## **Pre-Application Briefing to Committee**

**Reference No:** PPA/2024/0005

**Address:** 30-48 Lawrence Road, London, N15 4EG

Report of Formal Review Meeting: 30-48 Lawrence Road

Front Façade (West facing)

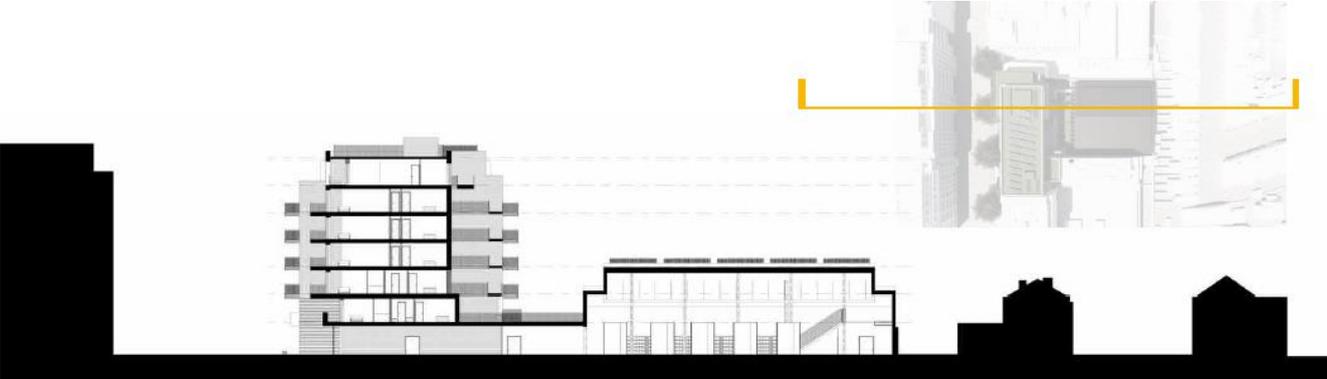
- The horizontal bands of brick balconies are overly dominant, particularly in views from Lawrence Road. While the benefits of solid balconies for overheating mitigation are understood, the proposals feel out of keeping with the language of their context.

- The panel suggests further iterations exploring alternative materials and balcony treatments where the massing is broken up, and a more subtle approach is taken to horizontals and verticals. No. 28 Lawrence Road, immediately north of the site, is a helpful reference as it is simultaneously robust and playful in terms of horizontal and vertical elements.

- The colonnade on the elevation fronting Lawrence Road should relate only to the workspace uses. Extending this into the residential floors above confuses the clarity of uses that could be read in the façade design.
